Federal Register

[Docket No. FAA-2022-1647; Project Identifier AD-2022-01379-T]

Airworthiness Directives; Transport and Commuter Category Airplanes

ACTION: Notice of proposed rulemaking (NPRM).

Figure 1 to paragraph (g)(2) – Effective Power Spectral Density

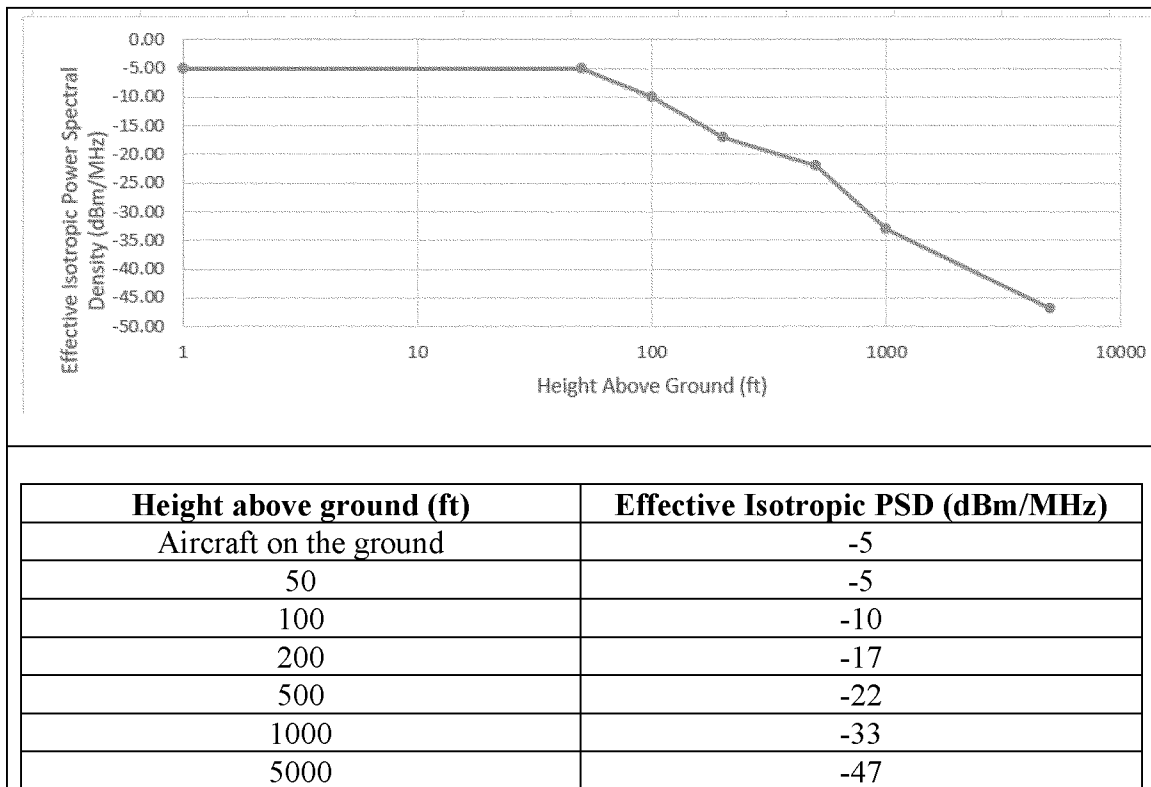
The interference tolerance requirements are represented by a power spectral density (PSD) curve. The PSD curve, as depicted in figure 1 to paragraph (g)(2) of this proposed AD, represents the height over the ground and received power from a 5G C-Band emitter, at or below which the radio altimeter is expected to function reliably, measured in decibels per megahertz. These measurements are limited to the 5G CMAs that will be listed in an FAA Domestic Notice. For purposes of this proposed AD, a “radio altimeter tolerant airplane” (also known within industry as a Group 4 airplane) is one for which the radio altimeter, as installed, demonstrates tolerance to radio altimeter interference at or above PSD curve threshold specified in figure 1 to paragraph (g)(2) of this proposed AD. A radio altimeter tolerant airplane also demonstrates tolerance to a spurious emission level of -48 dBm/MHz in the 4200–4400 MHz radio altimeter band. For purposes of this proposed AD, a “non-radio altimeter tolerant airplane” (also known in industry as a Group 1, 2, or 3 airplane) is one for which the radio altimeter, as installed, does not demonstrate those tolerances. Some radio altimeters may already demonstrate tolerance to the 5G C-Band emissions without modification. Some may need to install filters between the radio altimeter and antenna to increase a radio altimeter’s tolerance. For others, the addition of a filter will not be sufficient to address interference susceptibility; therefore, the radio altimeter will need to be replaced with an upgraded radio altimeter. The FAA has determined that radio altimeter tolerant airplanes will not experience the unsafe condition at any airport identified by the FAA as a 5G CMA in an FAA Domestic Notice.

(i) Tolerance to radio altimeter interference at or above the power spectral density (PSD) curve threshold specified in figure 1 to paragraph (g)(2) of this AD.

(ii) Tolerance to an aggregate base station conducted spurious emission level of -48 dBm/MHz in the 4200-4400 MHz radio altimeter band.

(2) For purposes of this AD, a “radio altimeter tolerant airplane” is one for which the radio altimeter, as installed, demonstrates the tolerances specified in paragraphs (g)(2)(i) and (ii) of this AD, using a method approved by the FAA.
